City of Kirkland

01 - 26 - 2022

Kirkland Urban East

Design Response Conference

South Fire Access (Master Plan)

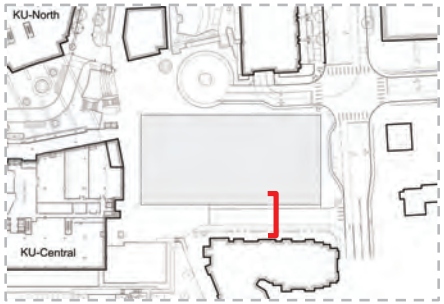
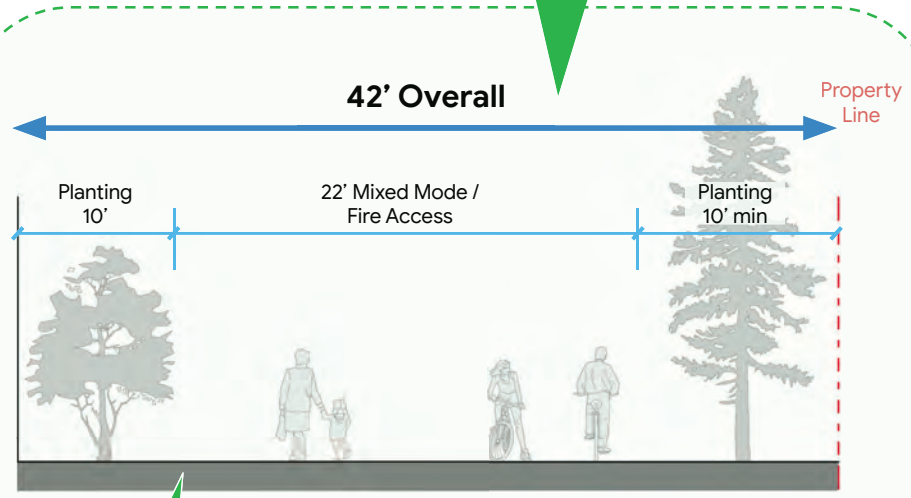
Fire department looking for 22' fire access lane

Bollards at 6th Street, No vehicle access except fire (Fire department request)

CDC Feedback: Building Design

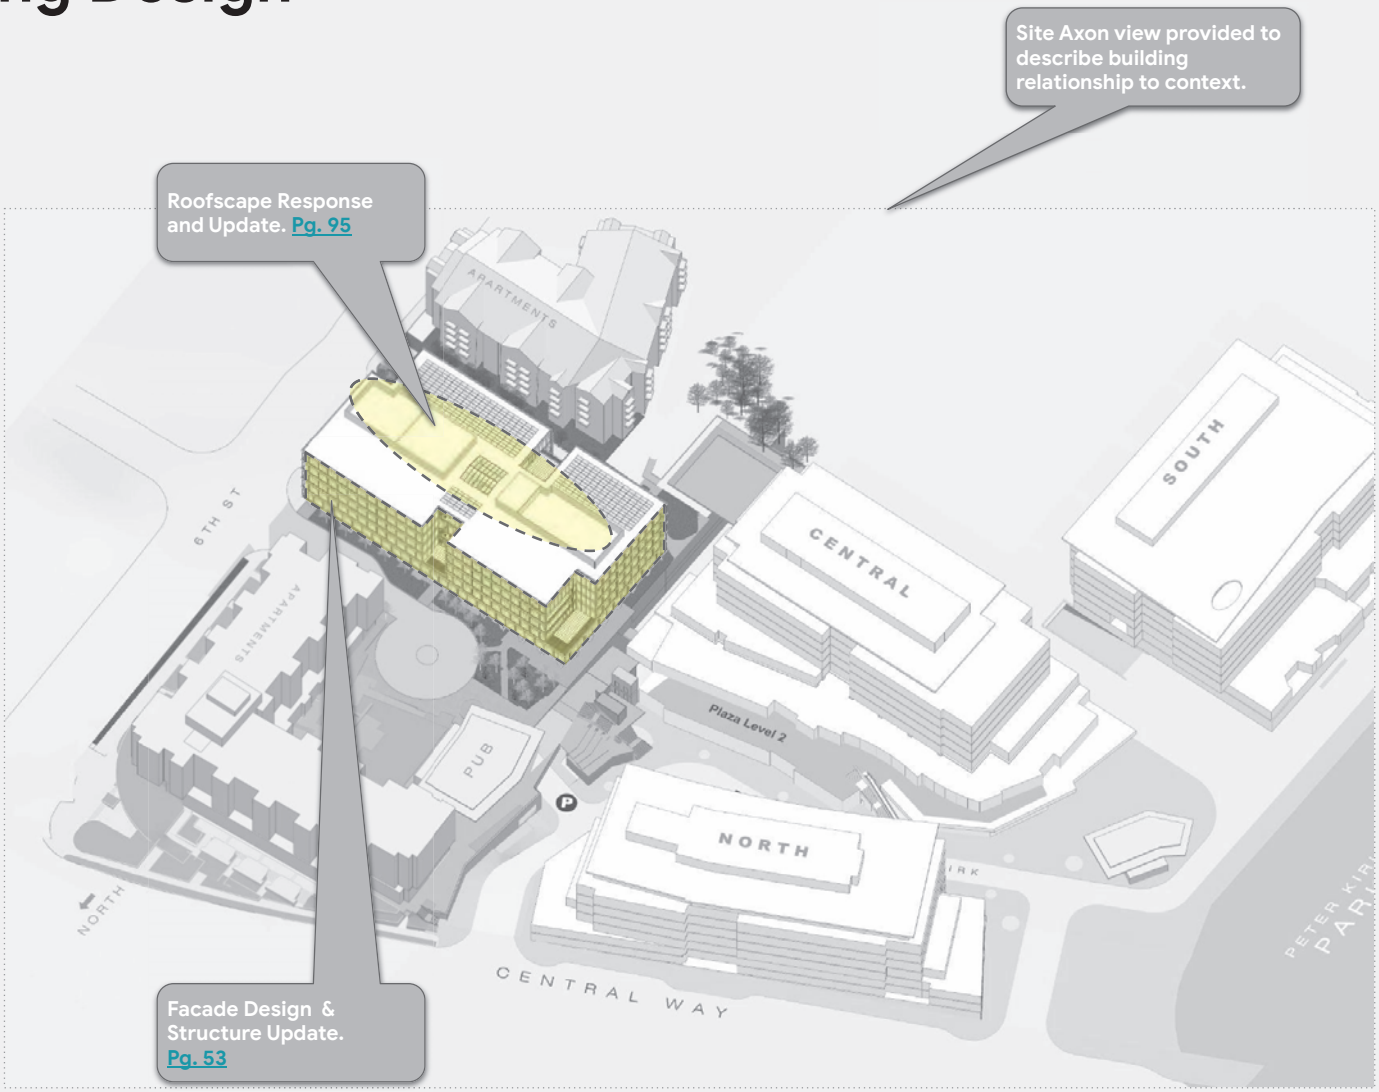
- The DRB supported applicant's preferred massing, Option 3.
- DRB members agreed that massing option 3 breaks down the massing using the cuts at the terraces and expressed interest in seeing how further facade development would contribute to breaking down the scale of the building.
- DRB members requested additional modeling views to better understand the buildings relationship to the site.
- DRB members expressed that they were interested in the building having a unique character in relation to the other buildings on site.
- We discussed that there was an intent to celebrate the timber structure through facade development.
- DRB requested further information on the roof design including mechanical enclosure and PV areas.

LEVER has continued to move forward with developing massing option 3. We've provided an axonometric, building renderings, facade studies, elevations and plans to show further development of the building.

CDC Feedback: Site Design

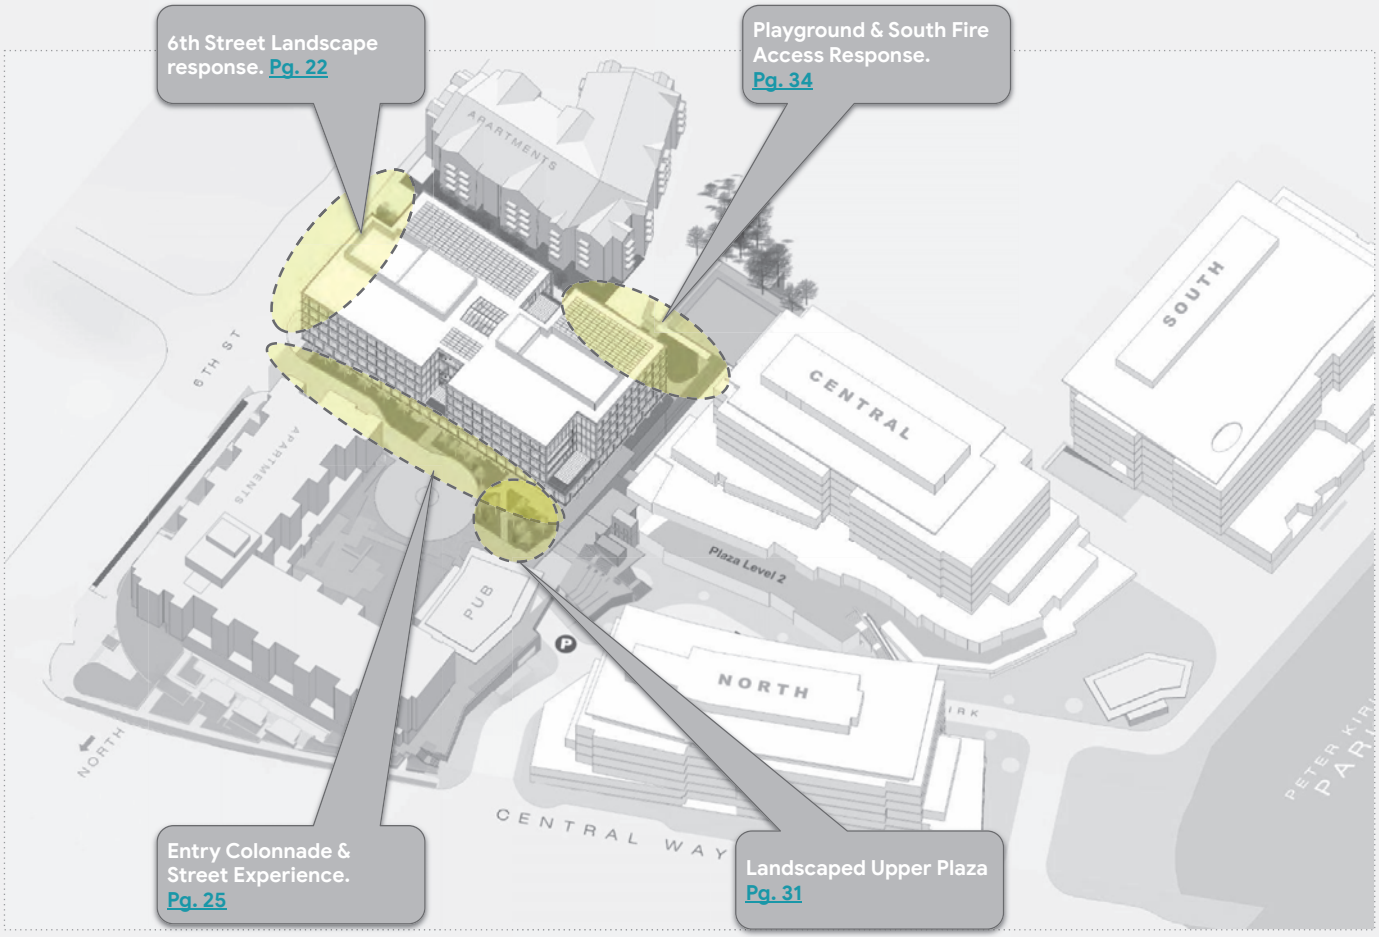
- The DRB supported the proposed vehicular and pedestrian access points to the site and requested further information about the pedestrian pathways.
- There was a particular point of interest in the connection through the site to the lower plaza and connection to the daycare area.
- Board members expressed interest in bringing in green/lush landscape, gatherings space, and family friendly features.

LEVER and GGN Landscape have provided plans, sections, and perspective views showing the character and the design intent and experience of the pedestrian pathways and how they connect to the existing site conditions.
